**MEETING AGENDA
SESSION OF THE HISTORIC PRESERVATION BOARD MEETING
CITY OF KISSIMMEE
CITY HALL, COMMISSION CHAMBERS
101 CHURCH STREET, KISSIMMEE, FLORIDA 34741-5054
MONDAY, DECEMBER 11, 2023 AT 5:15 PM**

509 Verona Street

New 72-square foot machine room at 509 Verona Street.

FRONT ELEVATION
SCALE: 1/4" = 1'-0"

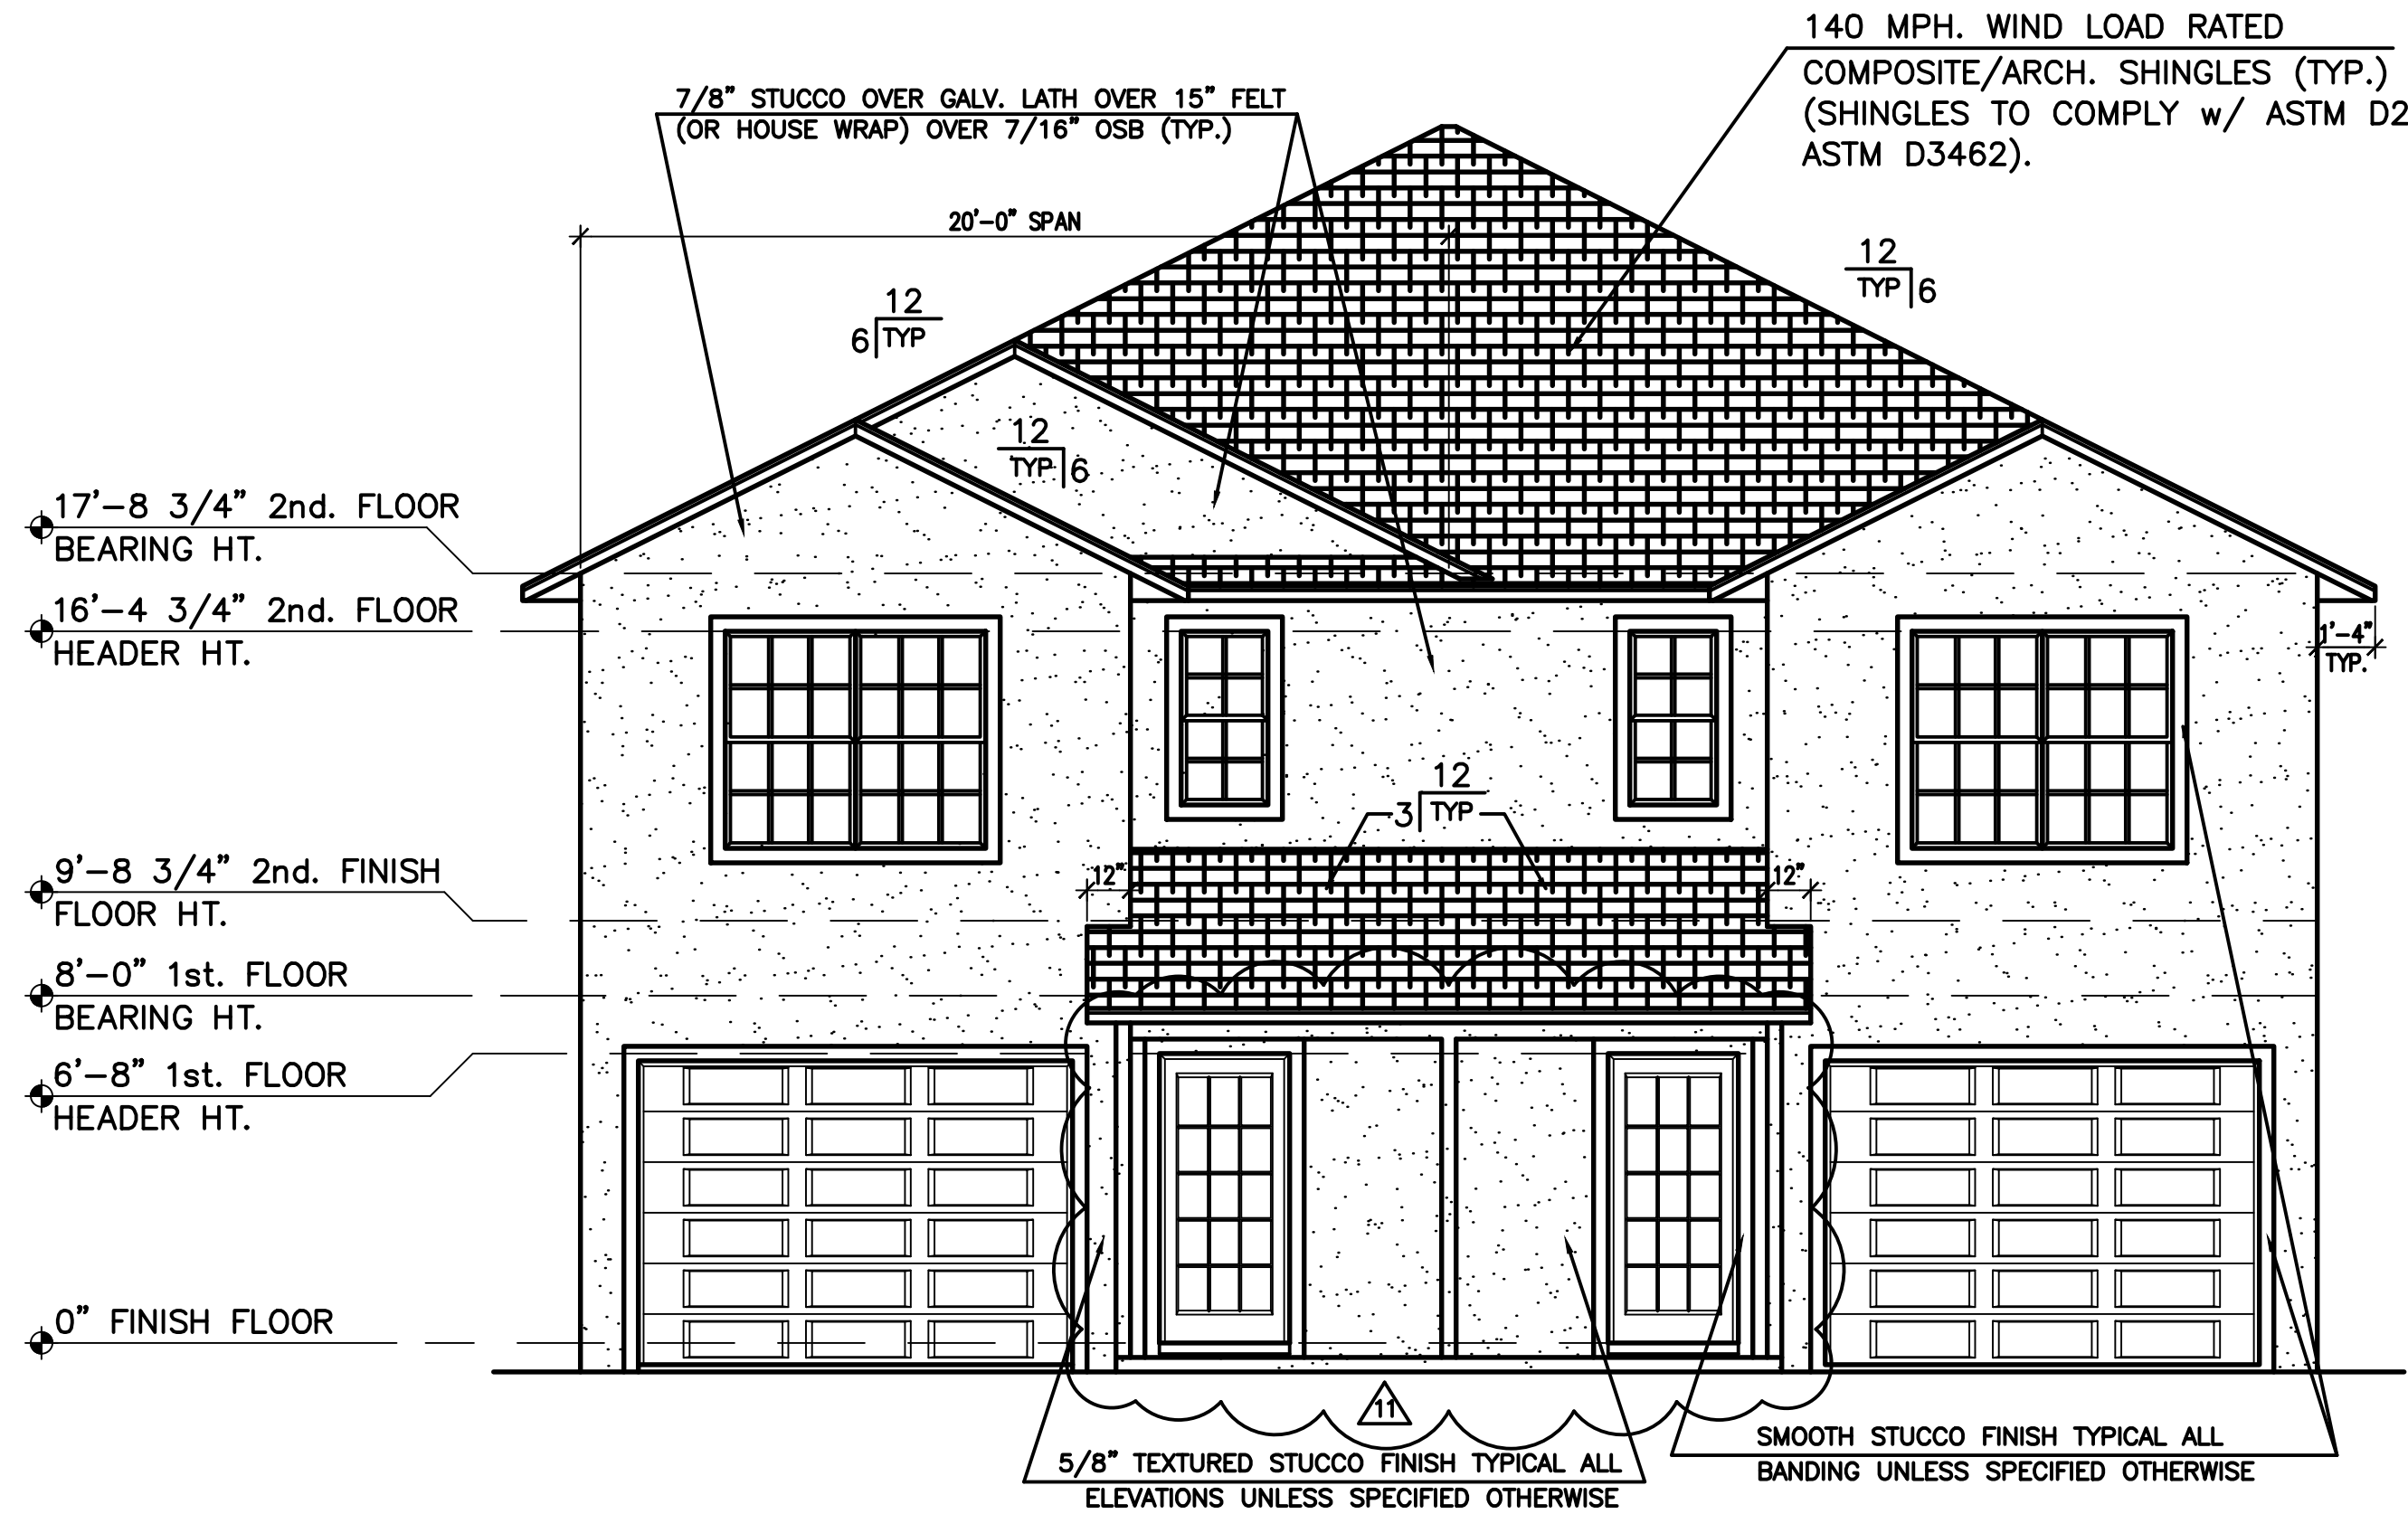
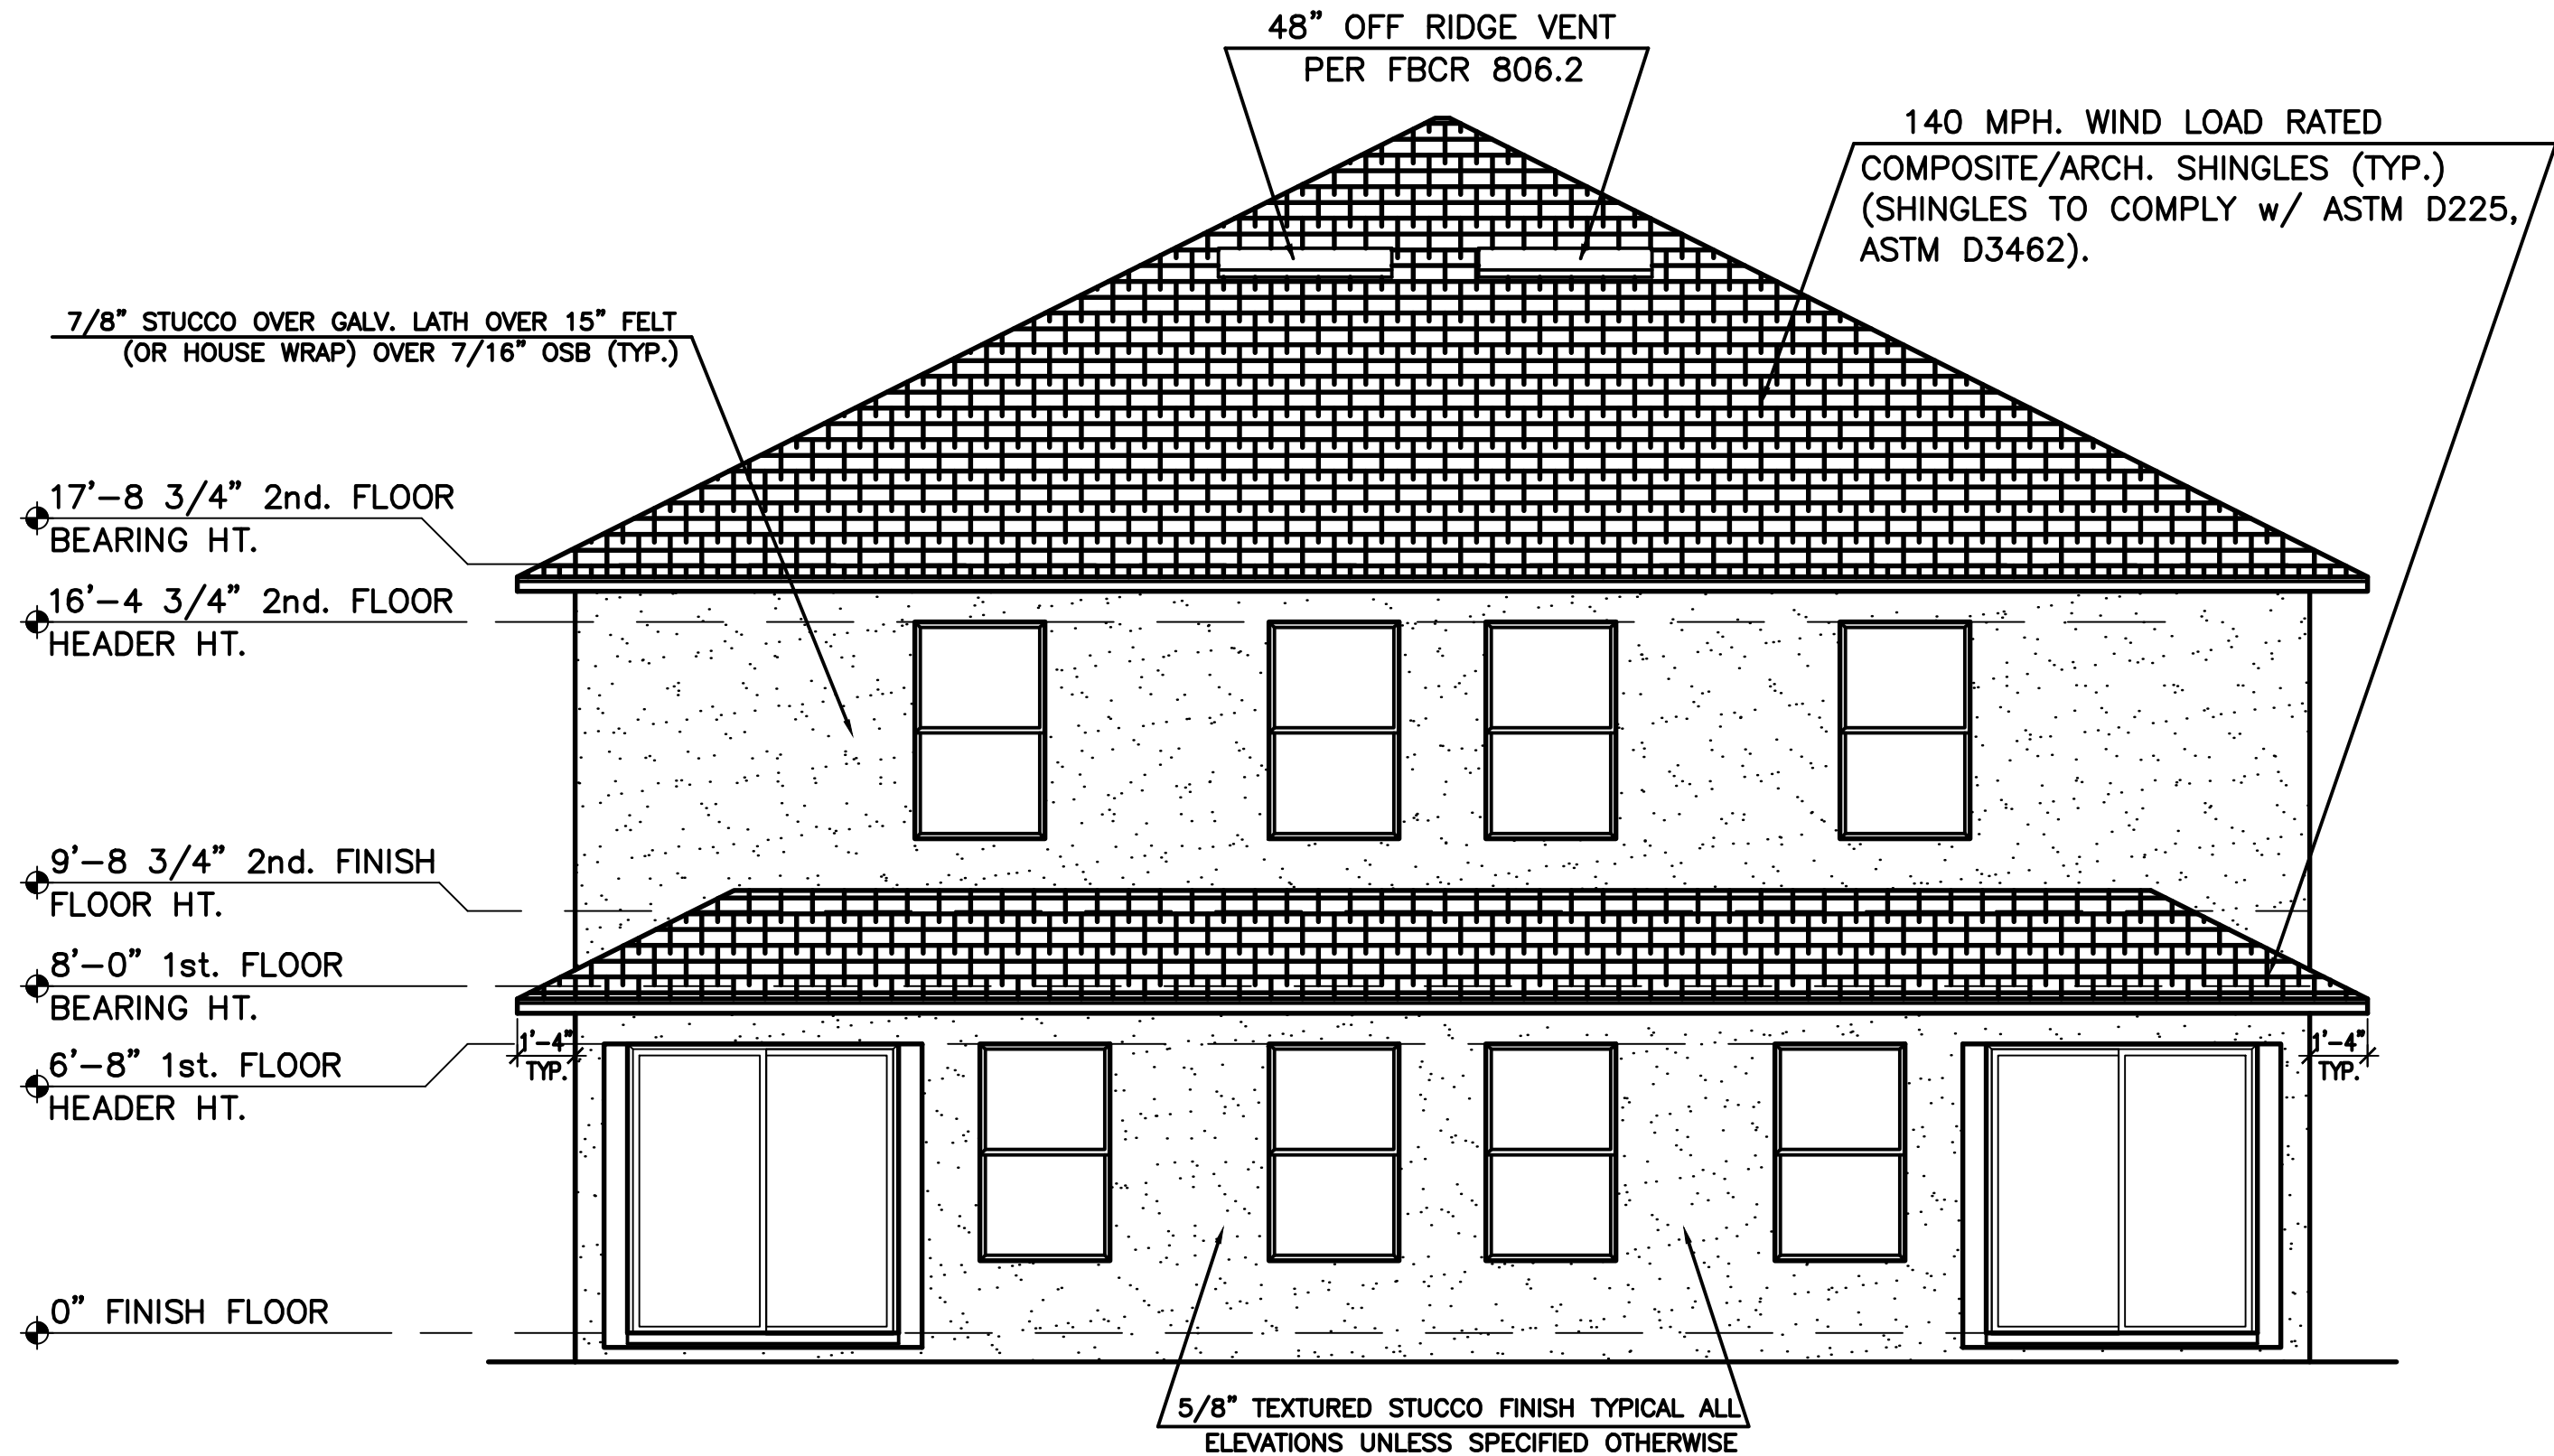
Since this property is on the edge of the South Beaumont district, and the only parcel fronting on Harford within the district, staff did not hold issue with a more modern design for the front of the structure. However, the proposed building is two stories and will be approximately 40-feet from the back of single-story structure at 725 Mabbette and the back and rear elevations will be seen from Mabbette. Due to this, staff is recommending that the applicant add architectural features to those elevations (sides and rear) to provide relief to the almost blank walls currently proposed. It is recommended to add additional windows and use some of the features from surrounding structures (e.g. a wide banding around the windows, a different window style, shutters, even window placement, and/or varying roof levels on the back). This will help make the transition between new and historic less awkward while respecting this property's location and proximity to newer construction.

Approval with the conditions that additional features be added to provide a smoother transition to the historic structures to the south.

1 FRONT ELEVATION
1/4" = 1'-0"

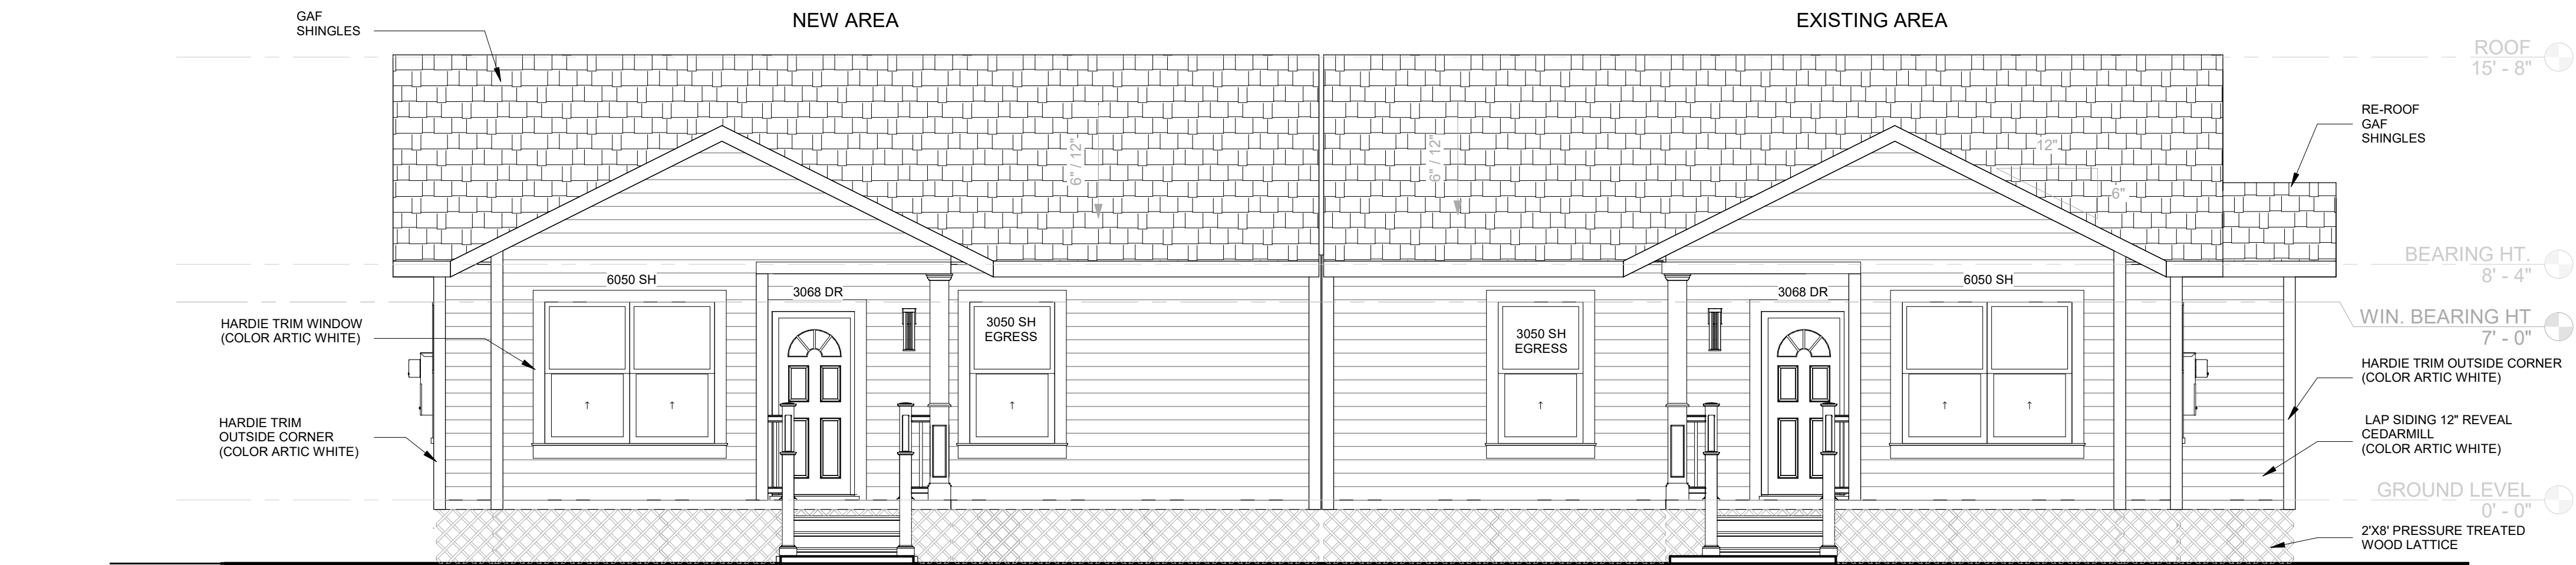
1. The front of the existing structure was reconfigured to add a small porch with the door recessed and off-center. Porches on frame vernacular homes typically span the entire front of the structure and the door is not recessed and centered. Per South Beaumont Historic Preservation guidelines, no porch, balcony or entry may be added to a structure unless compatible with historical, architectural character of the structure.
2. It appears that the front porch was enclosed at some point. An option is to open this area (it could be screened) and restore the porch, which would be consistent with the style and historic guidelines.
